# Low Temp Test procedure for EVs

ACEA TF EV proposal (update)

**New version – discussed in SG EV call on December 11<sup>th</sup>  
Including feedback/comments from SG EV members**

# Test Procedure (PEV) – Shortened Test Procedure or Consecutive Cycle Procedure

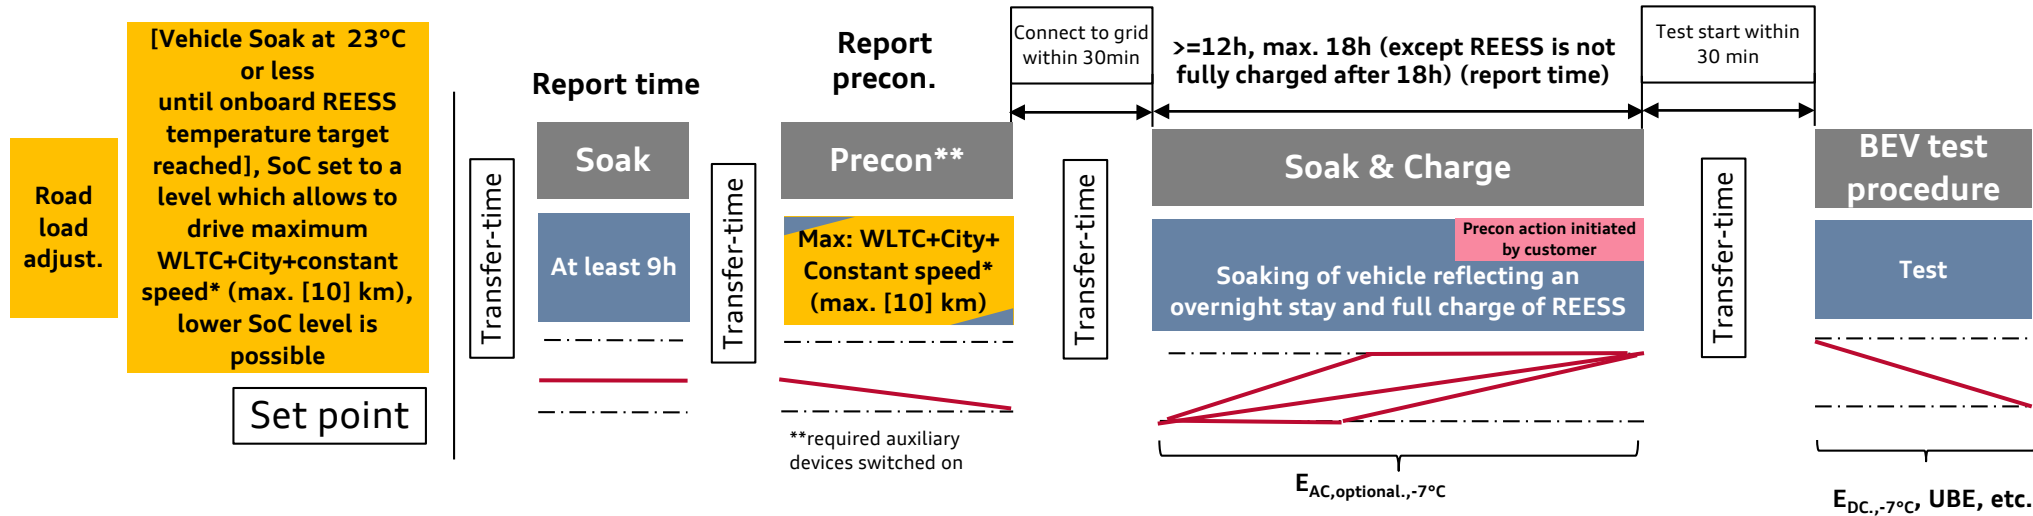
Feedback from SG EV web-audio 11.12.:

- Requirement necessary that the level of SoC at the end of preconditioning shall be “same” than after test procedure
- Preconditioning at 23°C: Further evidence needs to be given that this has no impact on the test result
- Constant speed during precon needs to be linked to constant speed in test procedure
- Break-off-criterion for precon shall be defined
- **Base procedure is mandatory and shall always need to be performed; optional procedure on next slides is only there for having procedure to evaluated the benefit of specific functions on the range value which will increase than**
- Focus on mandatory procedure and not on additional procedure for the moment

# Test Procedure (PEV) – Shortened Test Procedure or Consecutive Cycle Procedure

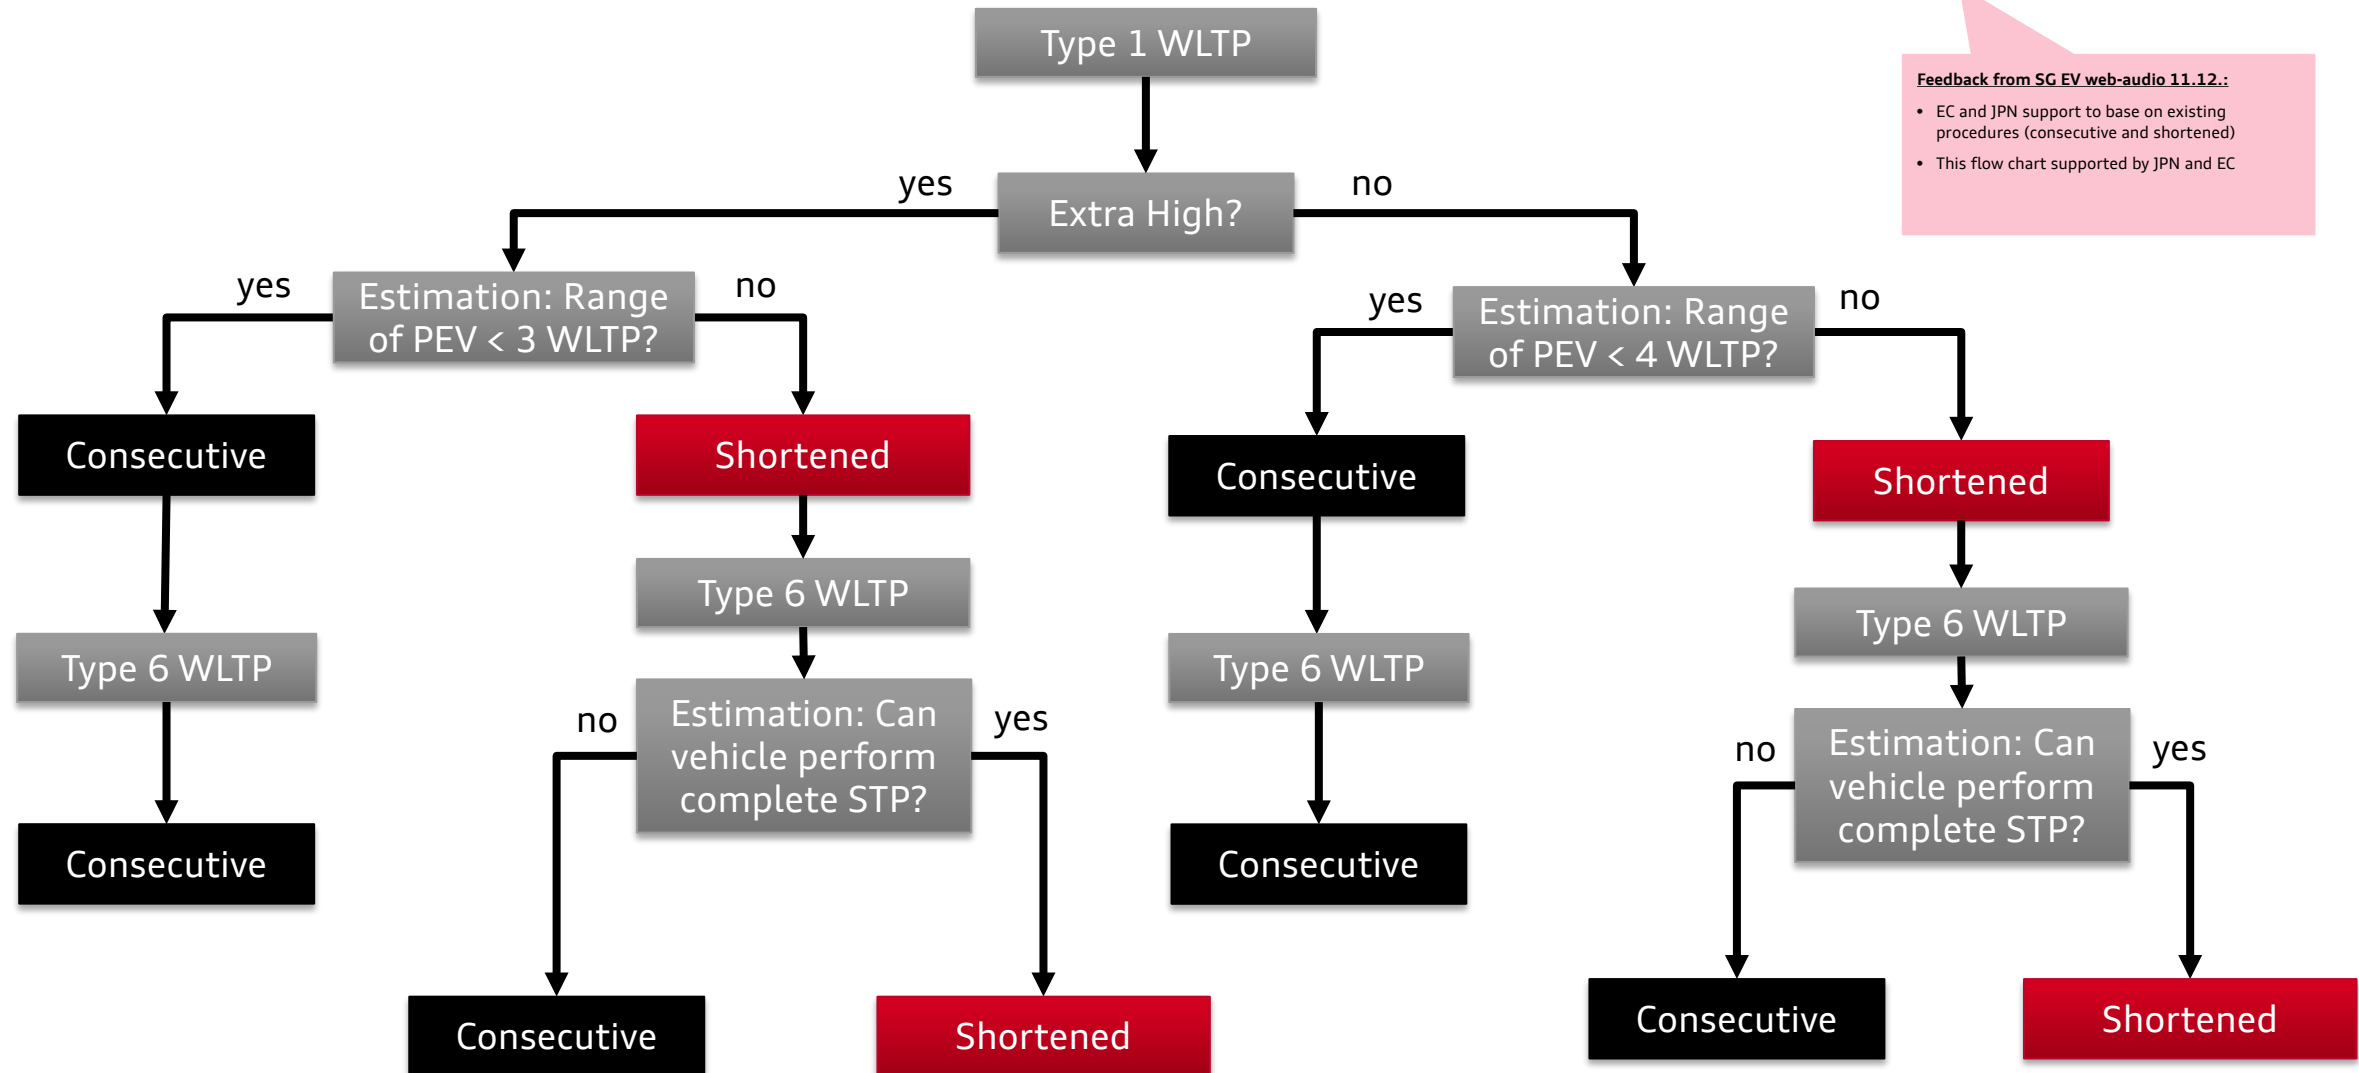
## Feedback from SG EV web-audio 11.12.:

- Requirement necessary that the level of SoC at the end of preconditioning shall be “same” than after test procedure
- Preconditioning at 23°C: Further evidence needs to be given that this has no impact on the test result
- Constant speed during precon needs to be linked to constant speed in test procedure
- Break-off-criterion for precon shall be defined
- **Base procedure is mandatory and shall always need to be performed; optional procedure on next slides is only there for having procedure to evaluated the benefit of specific functions on the range value which will increase than**
- Focus on mandatory procedure and not on additional procedure for the moment

# Test Procedure (OVC-HEV) – Charge Depleting Test

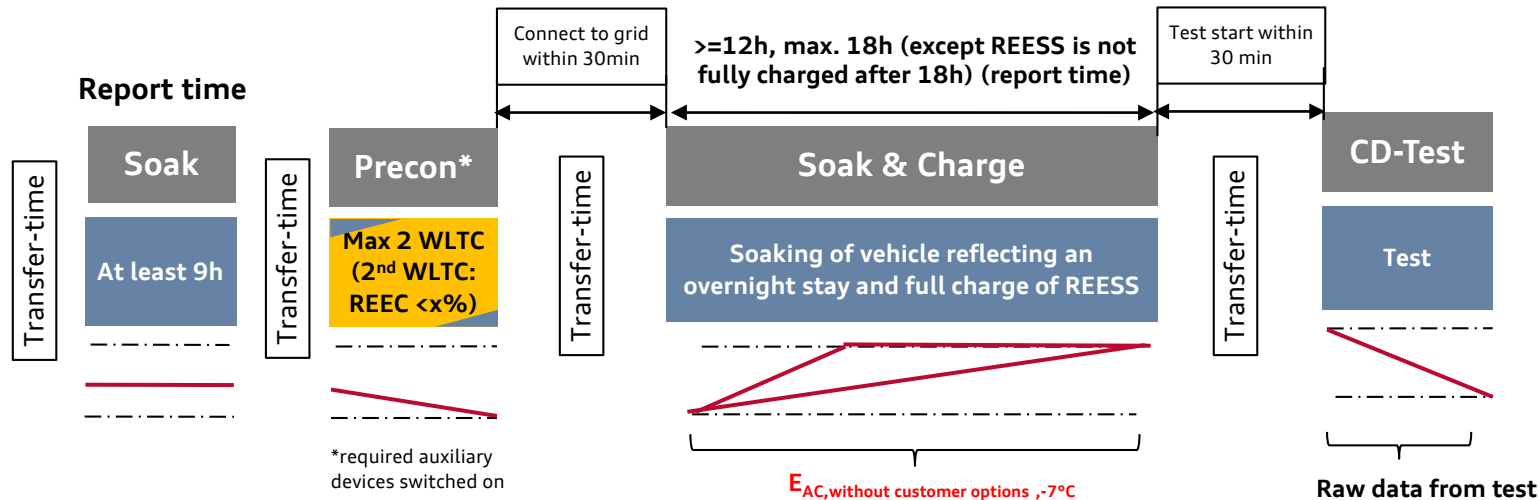
## Feedback from SG EV web-audio 11.12.:

- Requirement necessary that the level of SoC at the end of preconditioning shall be "same" than after test procedure
- Preconditioning at 23°C: Further evidence needs to be given that this has no impact on the test result
- **Base procedure is mandatory and shall always need to be performed; optional procedure on next slides is only there for having procedure to evaluated the benefit of specific functions on the range value which will increase than**
- Focus on mandatory procedure and not on additional procedure for the moment

# Test Procedure (OVC-HEV) – Charge Depleting Test

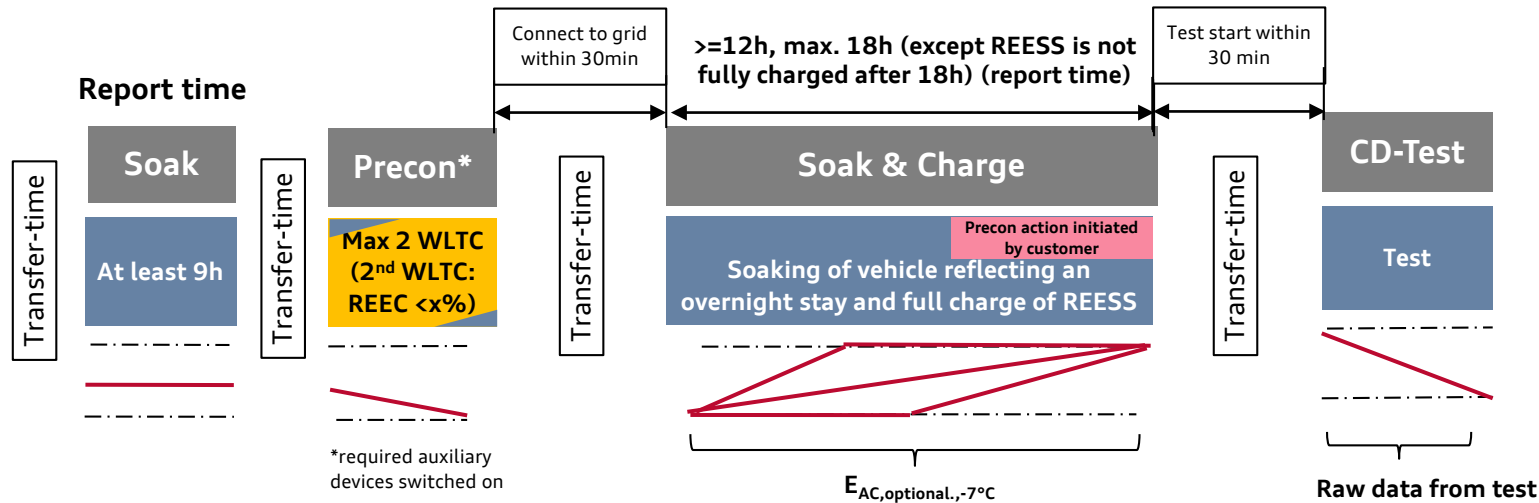
## Feedback from SG EV web-audio 11.12.:

- Requirement necessary that the level of SoC at the end of preconditioning shall be "same" than after test procedure
- Preconditioning at 23°C: Further evidence needs to be given that this has no impact on the test result
- Base procedure is mandatory and shall always need to be performed; optional procedure on next slides is only there for having procedure to evaluated the benefit of specific functions on the range value which will increase than
- Focus on mandatory procedure and not on additional procedure for the moment
